MOL-EFT PROGRAM

MODEL SPECIFICATION
AIRBORNE VEHICLE EQUIPMENT

MOL-EFT-AVE-1000

REVISION NO. 1

FIG I-B* STRUCTURAL ARRANGEMENT & MECHANICAL INTERFACE DRAWING

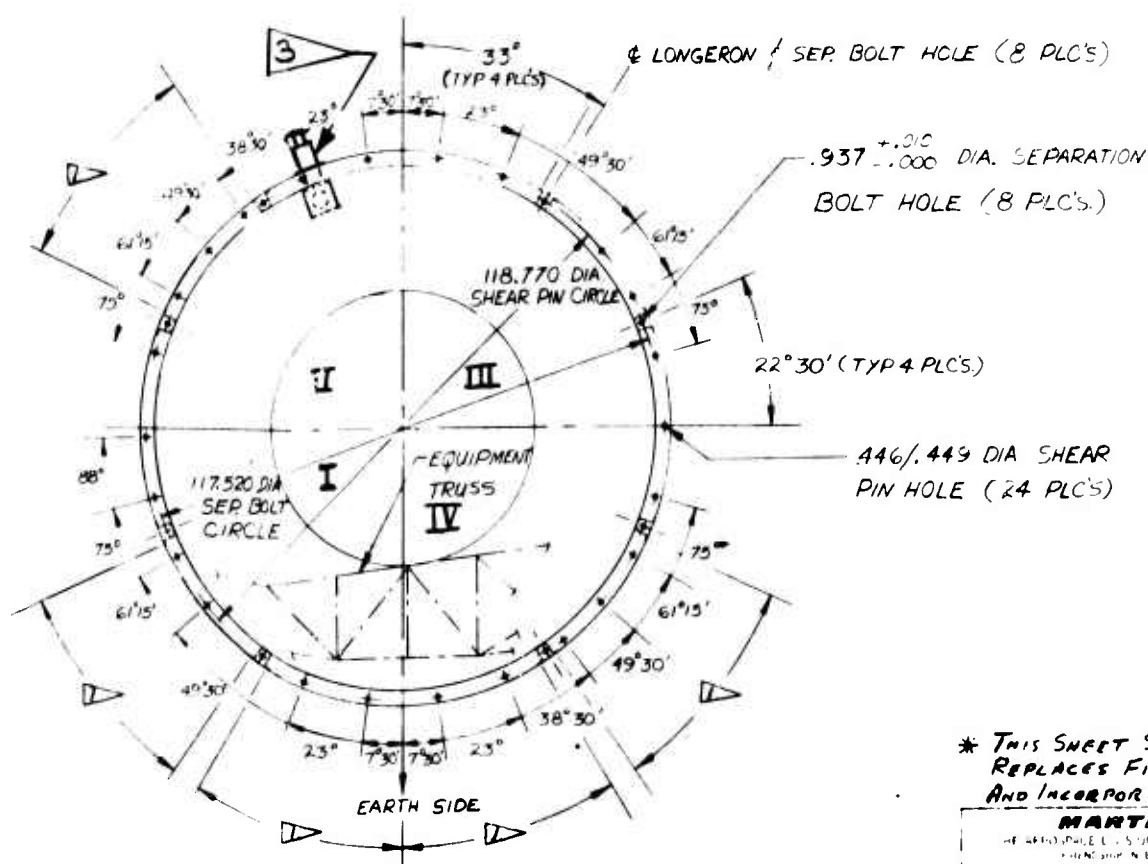
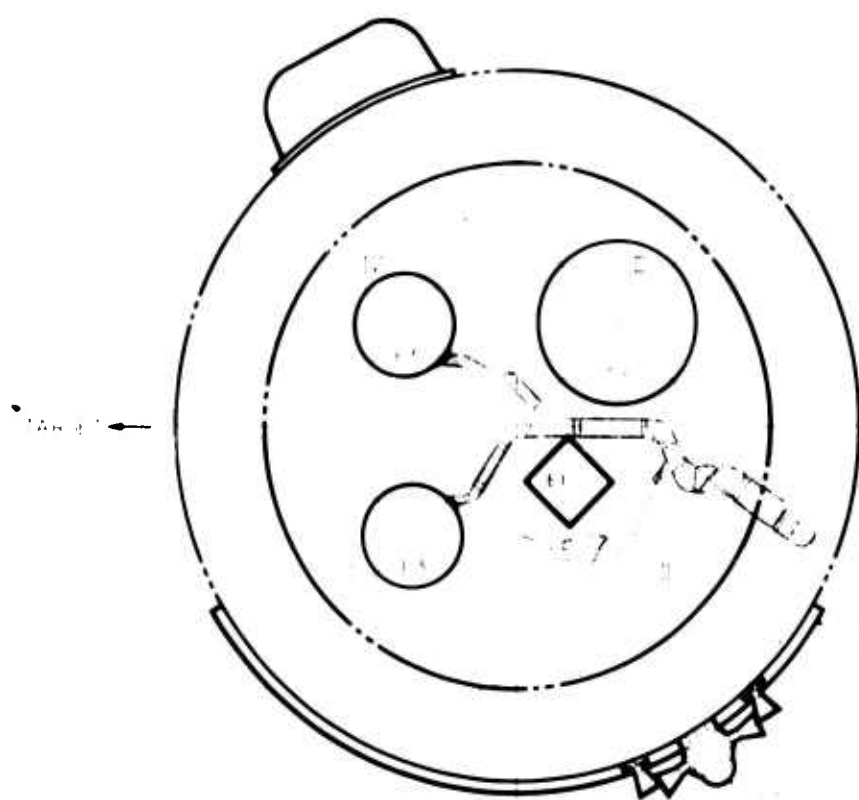
1.  EQUIPMENT & ENTRY ACCESS DOORS.
2. INDICATIONS OF FRAMES & STRINGERS ARE FOR INFORMATION ONLY AND ARE NOT TO BE USED FOR INSPECTION PURPOSES.
3.  SCN#1
4.  CONNECTOR AIR CONDITIONING FLY-AWAY UMBILICAL ADDED BY SCN#10

* THIS SHEET SUPERSEDES AND REPLACES FIGURE I-B, PAGE 8 AND INCORPORATES SCN#10

(SCN 10) 3.3.1.2.3 Aft Adapter Assembly - The aft adapter assembly shall consist of that structure extending back from the aft end of the Laboratory tank assembly to the tension splice of the Transtage mating plane at Titan IIIC Station 77.0. (For reference, see Figure 29A of Specification SSS-TIII-010 SLV, pp 231a). The aft adapter section shall be constructed of aluminum alloy semi-monocoque skin panels and frames. An 8 inch air conditioning fly-away umbilical connector shall be provided on the aft adapter assembly.

AUTHORITY DATE BY CHECKED APPROVED TITLE	ADDED EXPERIMENTS MOL-HSO MOL-EET-AVE-1000.01 E FIGURE 1-C
---	---

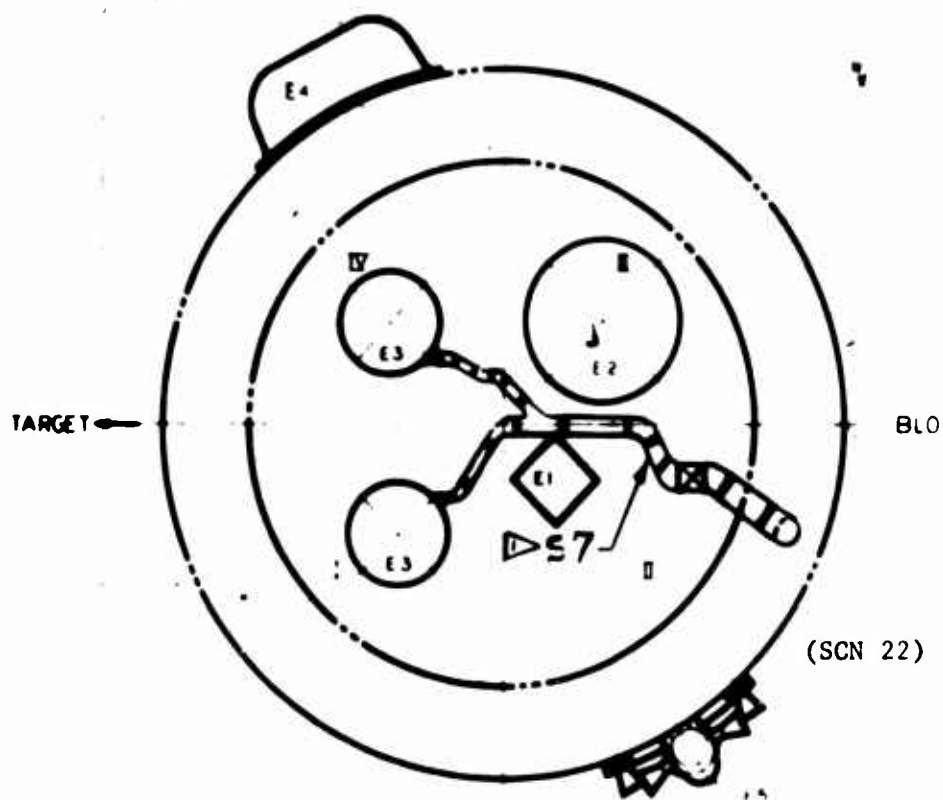
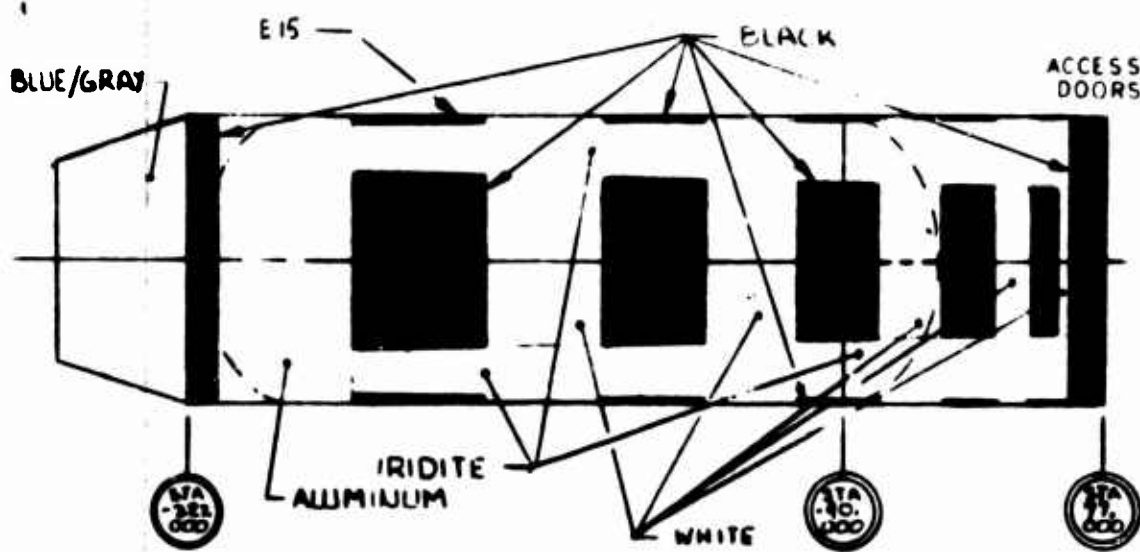
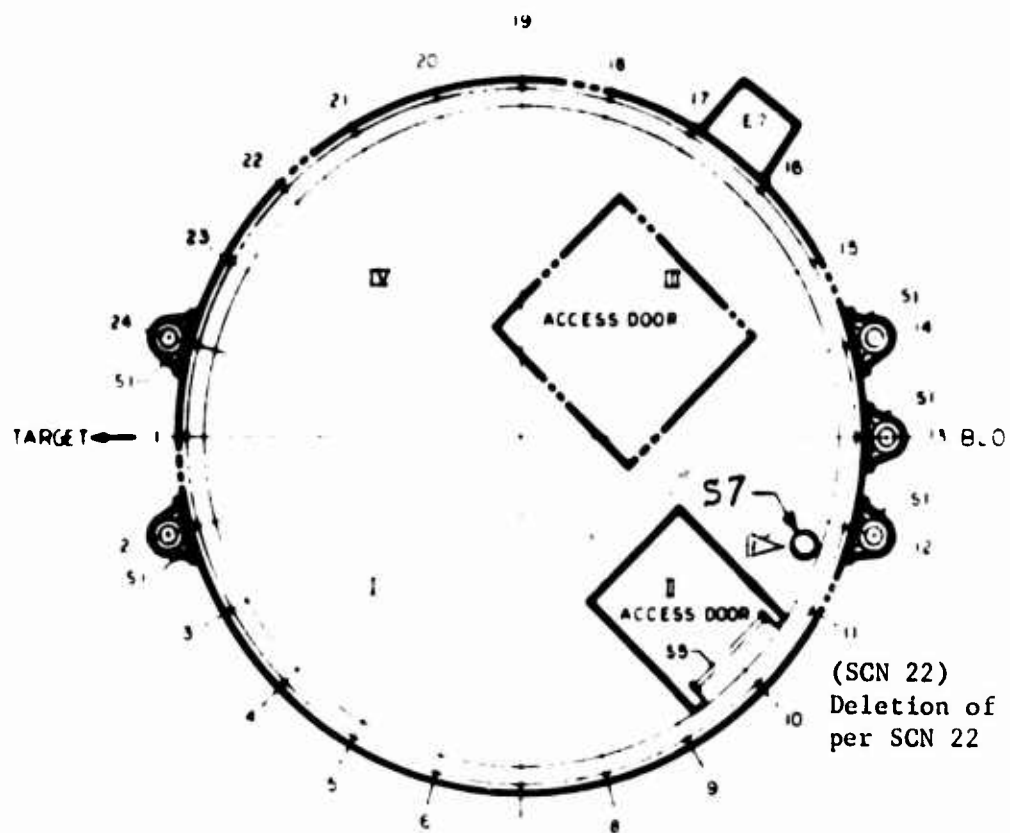
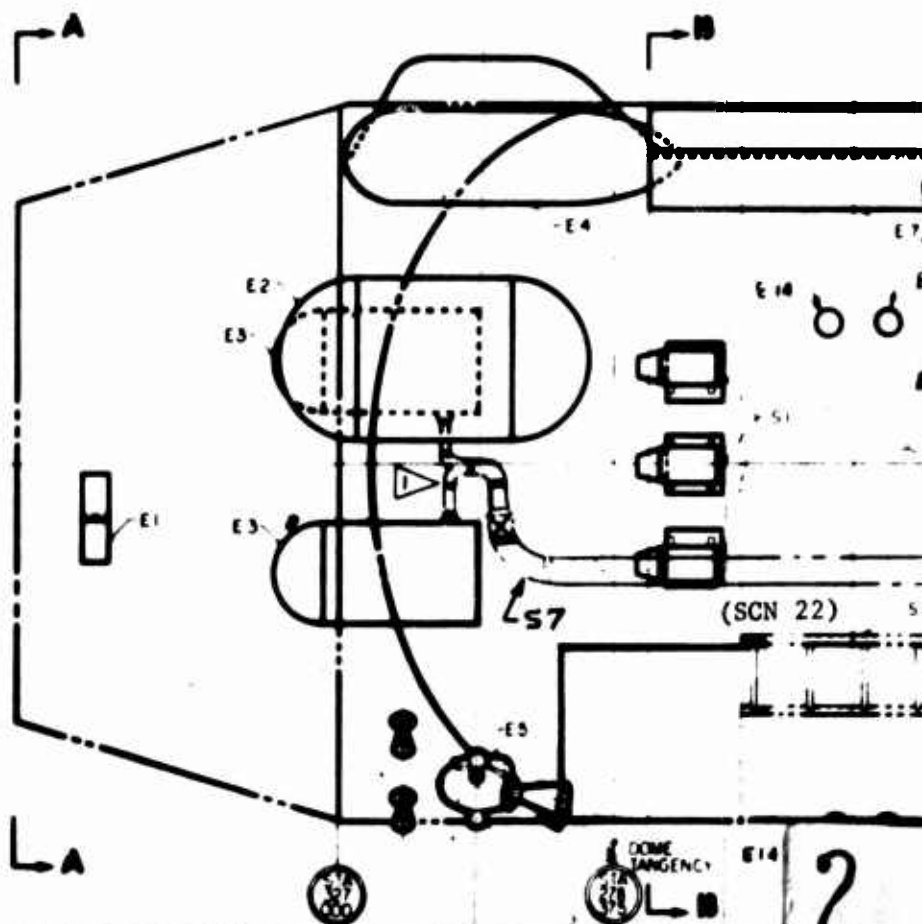
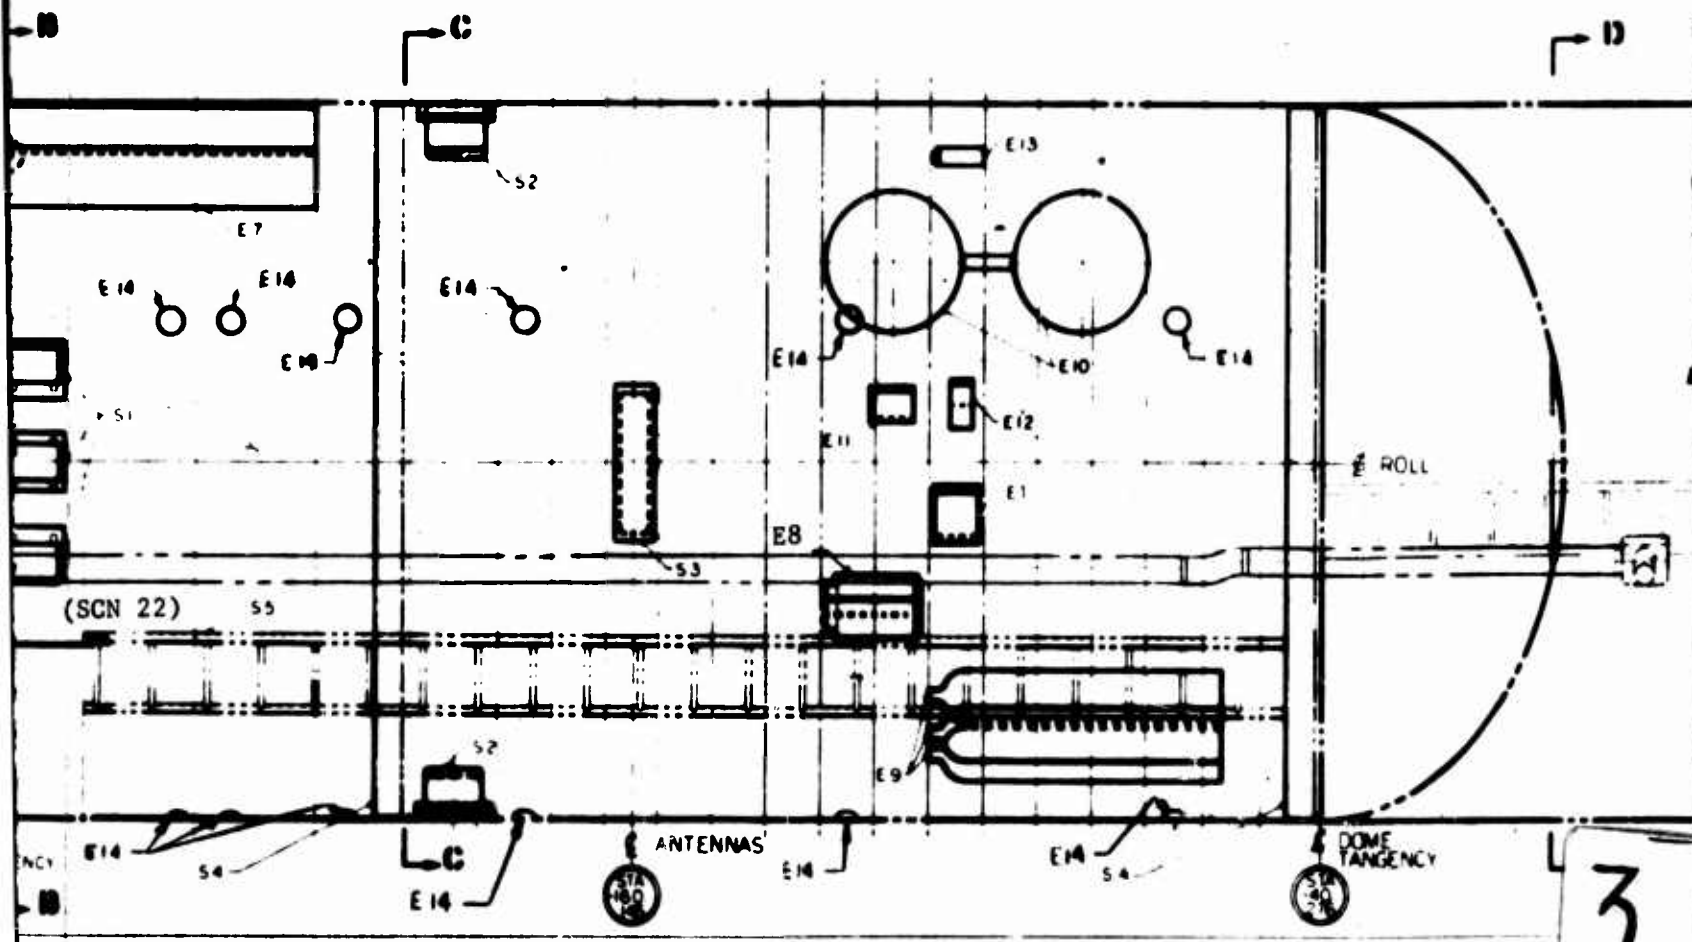
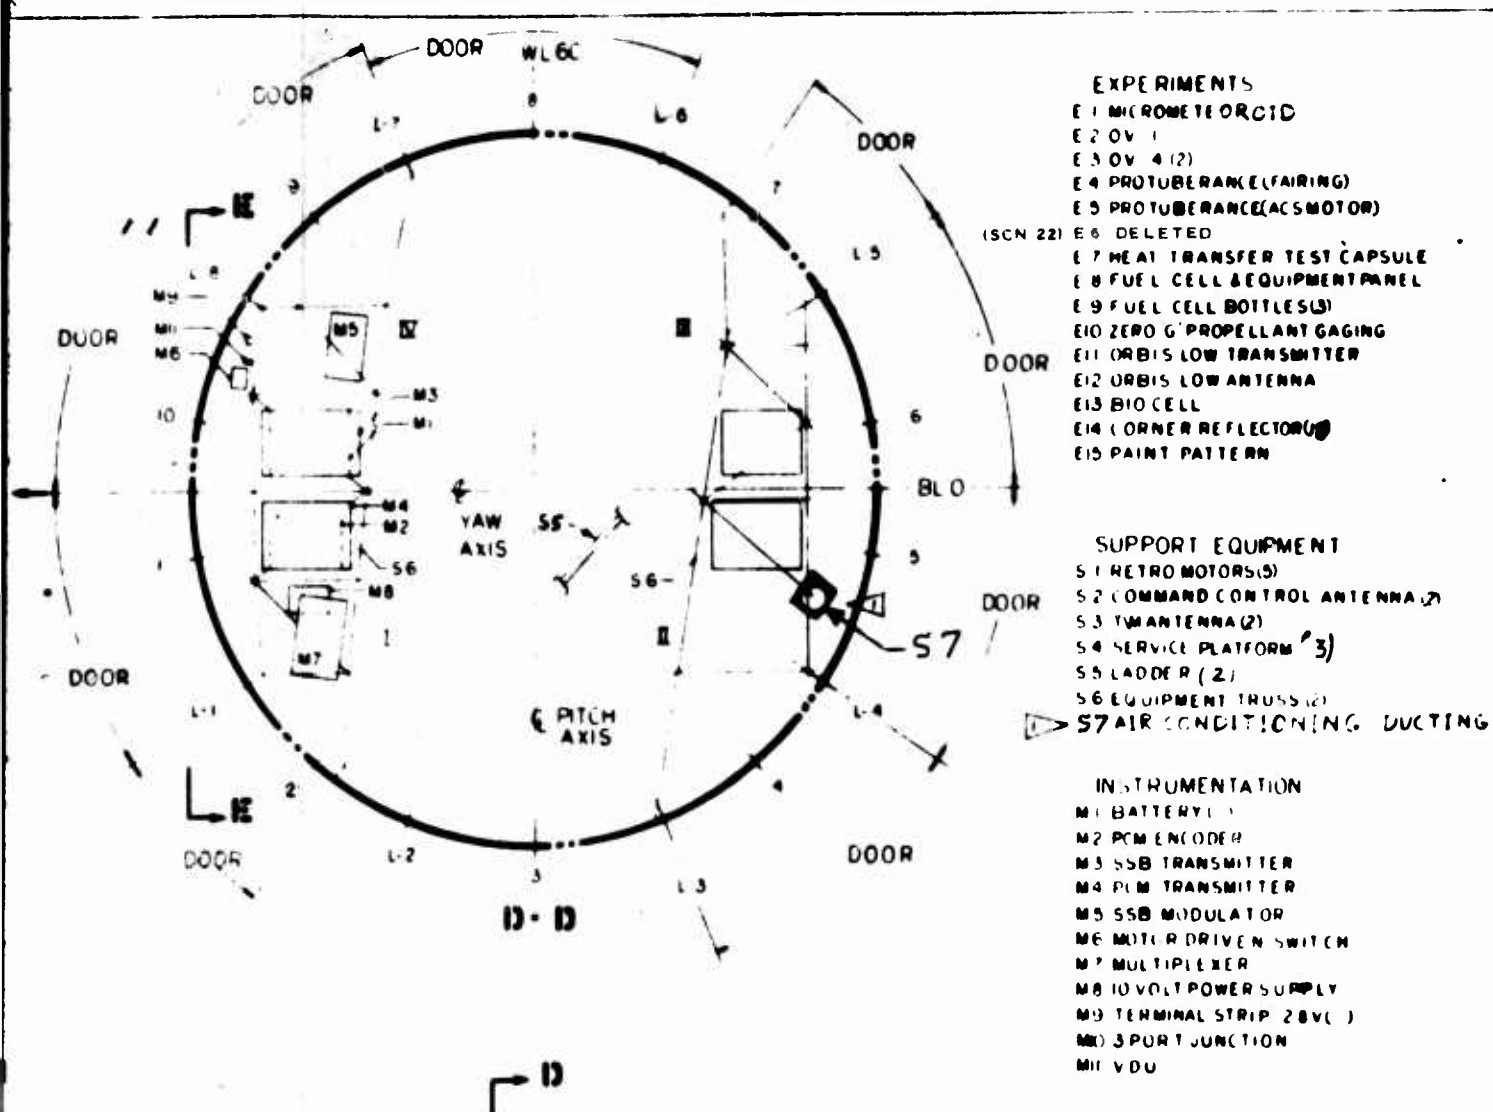
(SCN 22)
Deletion of E-6 Panel
per SCN 22

This Sheet Supersedes and Replaces Figure 1-C, Page 8a and Incorporates SCN 22 dated 23 December 1966
